Eugene S. Grecheck
Vice President
Nuclear Development

DOMINION VIRGINIA POWER
NORTH ANNA UNIT 3 COMBINED LICENSE APPLICATION
SRPs 12.03 and 12.04: RESPONSE TO RAI LETTER 92

RAI 5977, Question 12.03-12.04-14

QUESTION NO.: 12.03-12.04-14

Figure 9.3.4-1R Chemical and Volume Control System Flow Diagram (Sheet 4 of 7)

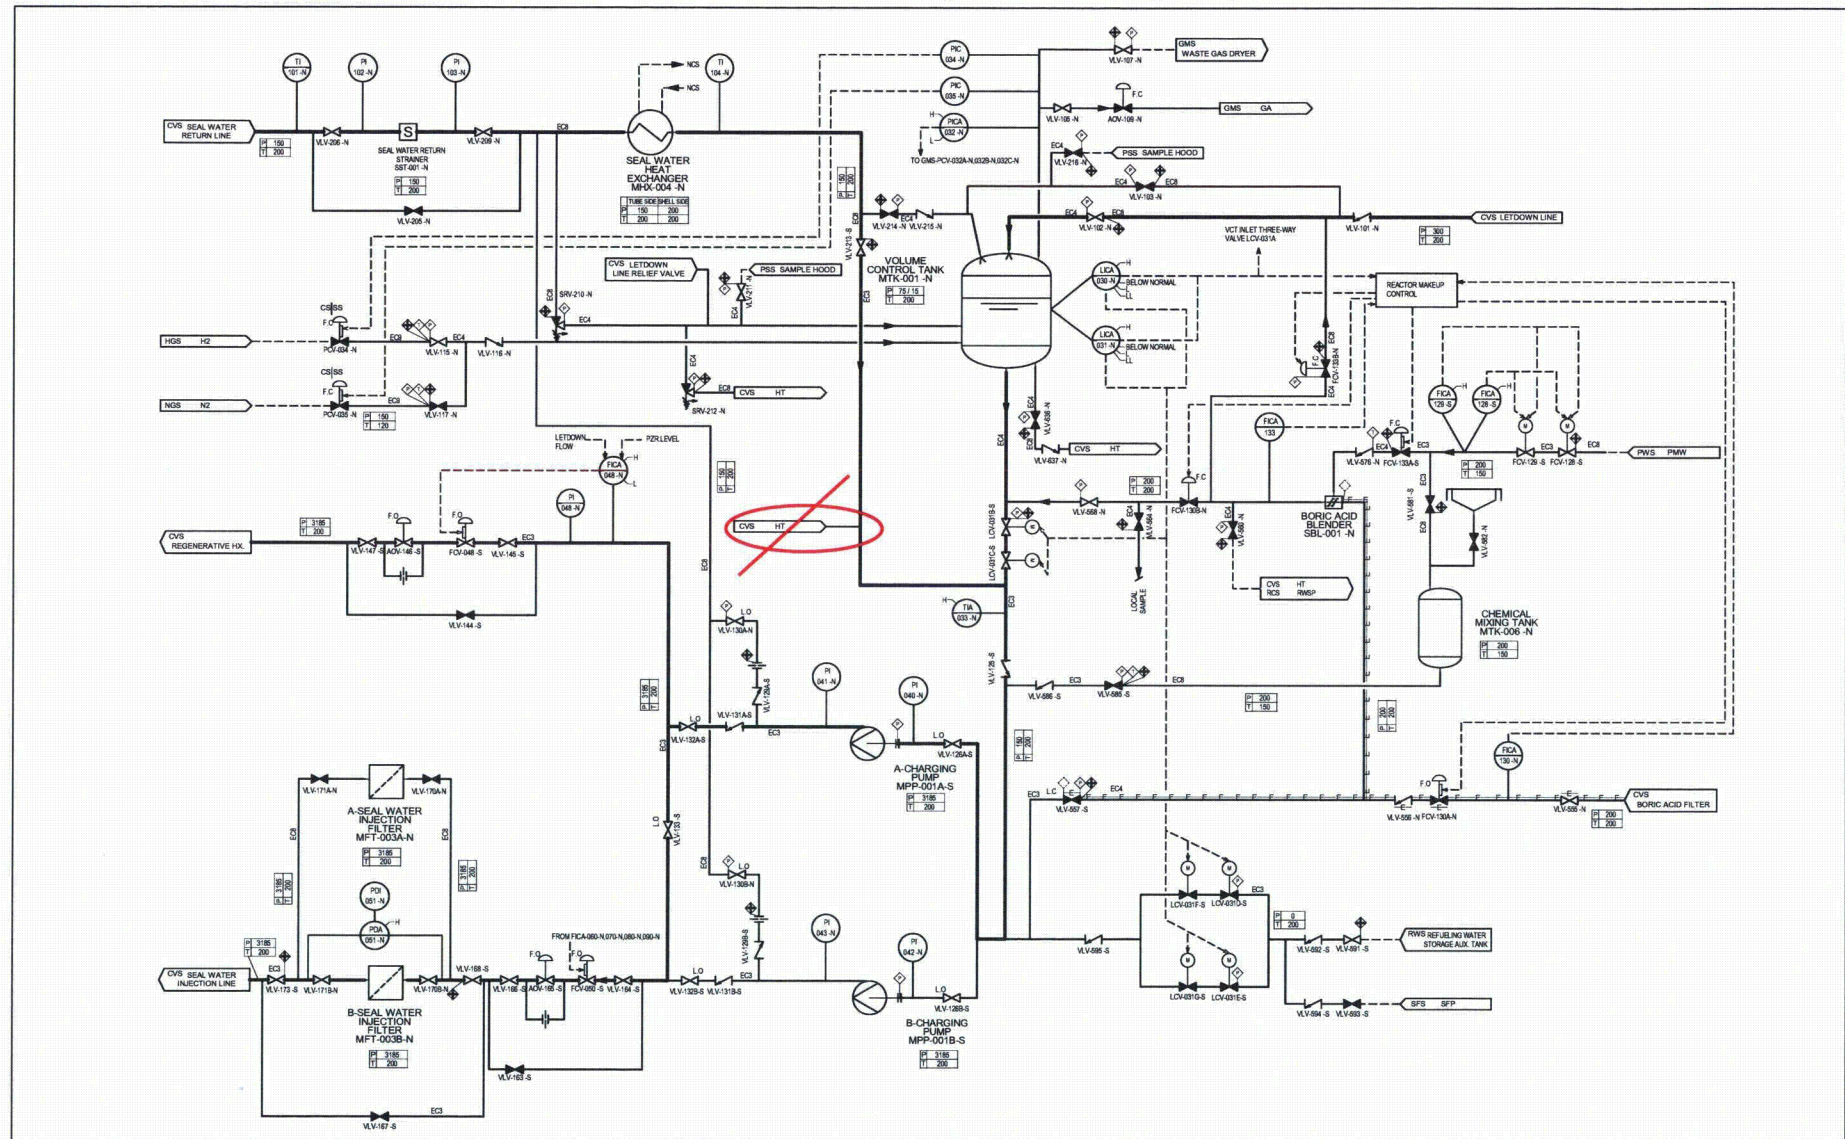
Supplemental Response to NRC Request for Additional Information (RAI) North Anna Power Station Unit 3 (NAPS) Combined License (COL) Letter 65 RAI 5548, Question 09.03.04-1 dated June 9, 2011, states that a connection between the Chemical and Volume Control System (CVCS) Holdup Tanks (HUT) and the charging pumps was incorporated in to the plant design to allow reuse of borated water in order to reduce the operational consumption of boric acid. The RAI response further states that during refueling, the reactor coolant system (RCS) water level will be lowered by draining the RCS to one of the three available CVCS HUTs where it is stored until needed near the end of refueling operations when it can be transferred back to the RCS. This site specific intended use of the CVCS HUTs is not described in US-APWR Design Control Document (DCD) Tier 2 Revision 2 Subsection 12.2.1.1.3 "Chemical and Volume Control System" or in North Anna Power Station Unit 3 (NAPS) Combined License (COL) FSAR Subsection 12.2.1.1.3 "Chemical and Volume Control System," NAPS COL FSAR Subsection 9.3.4.2.6.10 "Holdup Tanks," or the NAPS COLA "Departures Report".

Please revise and update the NAPS COL FSAR Sections 12.2 and 12.3 to describe this site specific intended use of the CVCS Holdup Tanks and Holdup Tank Pumps, the impact on the assumed source term in the CVCS Holdup Tanks and the impact of this use of the CVCS Holdup Tanks on the area dose rates from the new line, and ALARA requirements of 10 CFR 20.1101(b), or describe the specific alternate approaches and the associated justification.

Dominion's June 9, 2011, response to RAI 5548, Question 09.03.04-1, described the re-use of RCS inventory during refueling through the use of the site-specific line connecting the Chemical and Volume Control System (CVCS) Holdup Tanks (HUTs) and the charging pumps. In conjunction with the S-COLA Departure 9.2(1) regarding the removal of a boron recovery (evaporator) system, the re-use of some portion of the RCS inventory was considered a potential cost saving option due to a reduction in boron consumption. Additional consideration by Dominion has determined that this option is not sufficiently beneficial to pursue. Therefore, Dominion no longer intends to use the CVCS HUTs to store RCS inventory during refueling for the subsequent transfer of that inventory back to the RCS via the charging pump. Accordingly, the North Anna Unit 3 site-specific piping that connects the CVCS HUTs to the suction of the charging pumps will be removed from the Unit 3 design. FSAR Figure 9.3.4-1R (Sheets 4 and 6 of 7) will be revised to show the removal of this connection.

FSAR Figure 9.3.4-1R (Sheets 4 and 6) will be revised as indicated on the attached markup.

Figure 9.3.4-1R Chemical and Volume Control System Flow Diagram (Sheet 6 of 7)

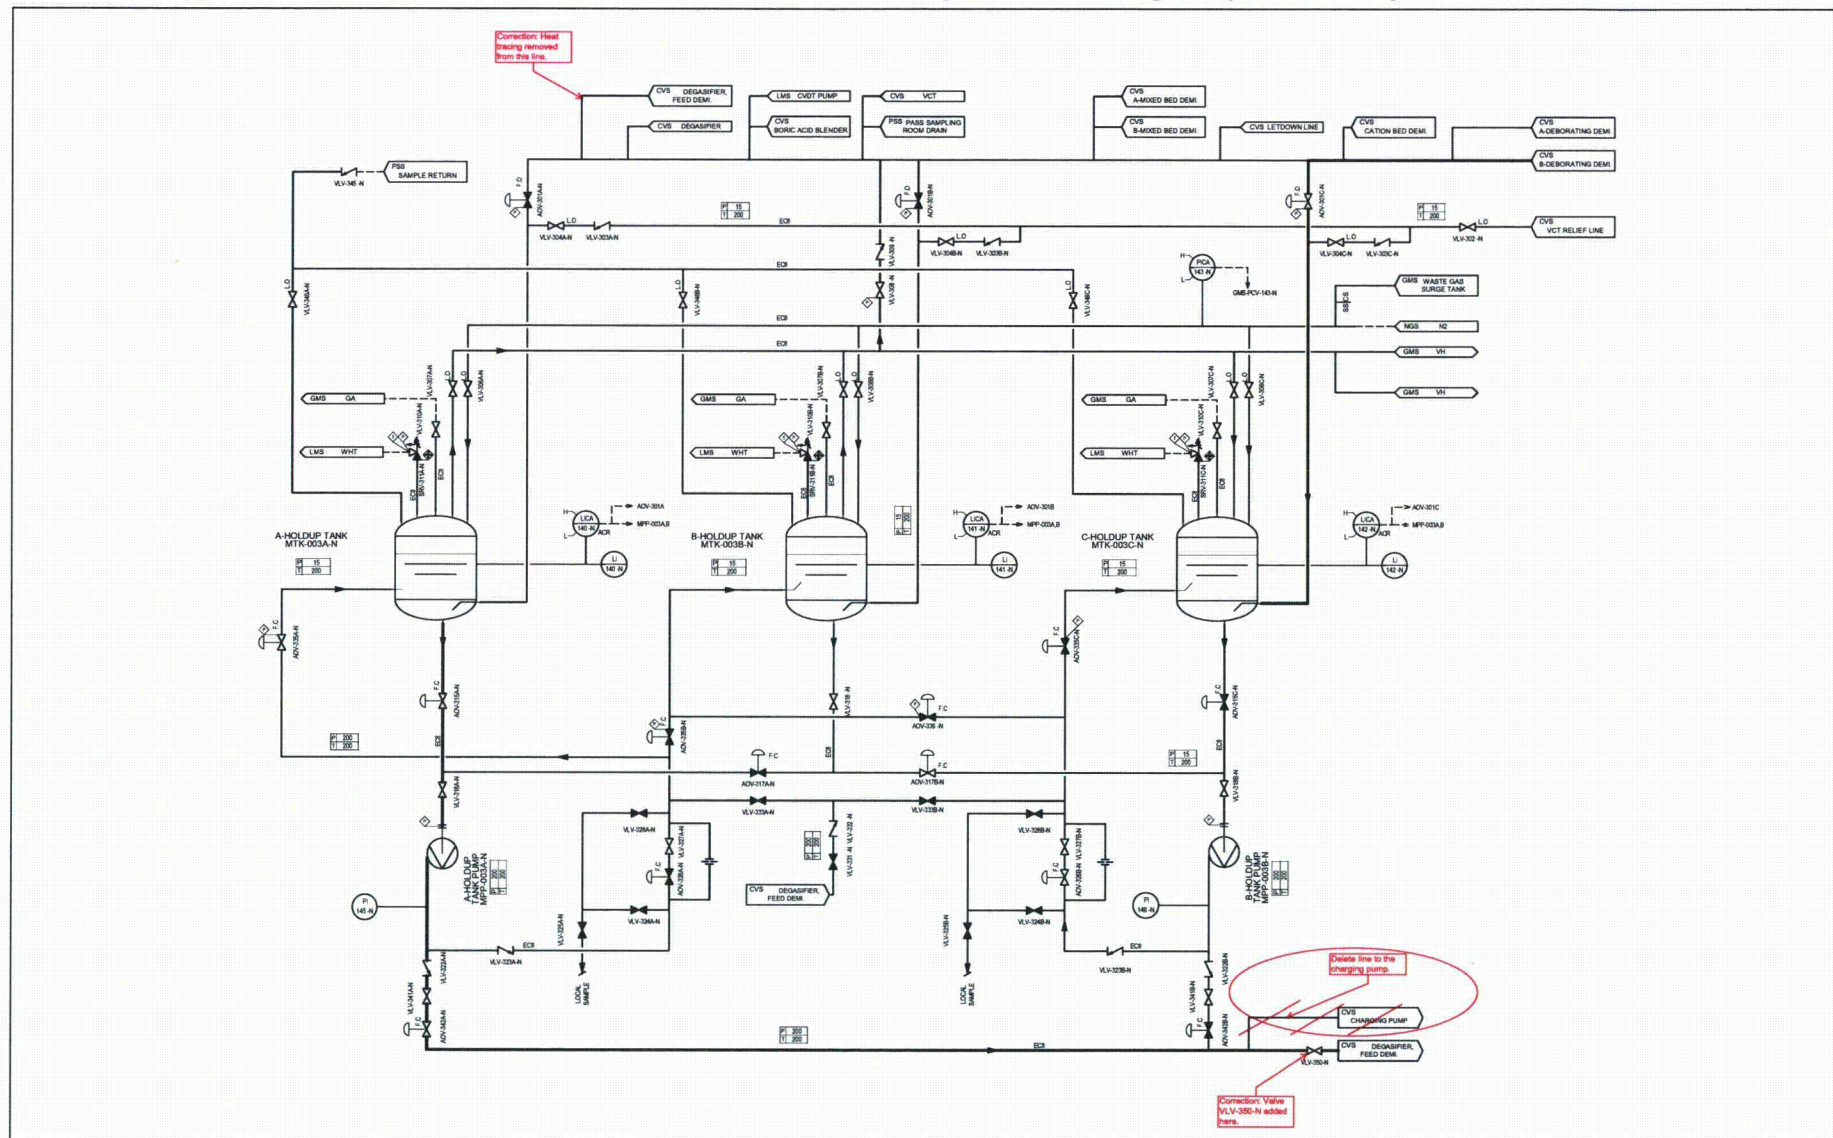
NAPS COL FSAR Figures 9.3.4-1R "Chemical and Volume Control System Flow Diagram (Sheet 6 of 7)" and 9.3.4-1R "Chemical and Volume Control System Flow Diagram (Sheet 7 of 7)" show a return line (2790) from the degasifier to the CVCS Holdup Tanks (HUT) and a return line from the degasifier feed demineralizer (2775) to the CVCS HUTs in addition to the line from the degasifier to the Waste Holdup Tank, without providing a description of the intended use of these lines, or the potential impact on the Degasifier, associated purification media, and area dose rates.

Please describe the purpose of these lines, the changes to the methods, models and assumptions used to determine degasifier and purification media activity, changes to shielding and the impact on radiation zones. Please revise and update the NAPS COL FSAR Sections 1.2.1.5.4.5 "Process Auxiliary Systems", 9.3.4 "Chemical and Volume Control System", 12.2 "Radiation Sources" and 12.3 "Radiation Protection Design Features" to describe the features or describe specific alternate approaches and the associated justification.

FSAR Revision 4, Figure 9.3.4-1R (Sheet 6 of 7) will be revised to show the following corrections:

1. The heat tracing on the return line from the degasifier feed demineralizer to the HUTs had been deleted since this piping does not contain evaporator concentrate and heat tracing is not required. However, the heat tracing was inadvertently retained on the drawing in Revision 4.

2. The valve on the holdup tank pump outlet line to the degasifier feed demineralizer (VLV-350-N) was removed in Revision 4 of this figure due to simplification of the P&ID. This valve will be added back to the figure as indicated on the attached markup.
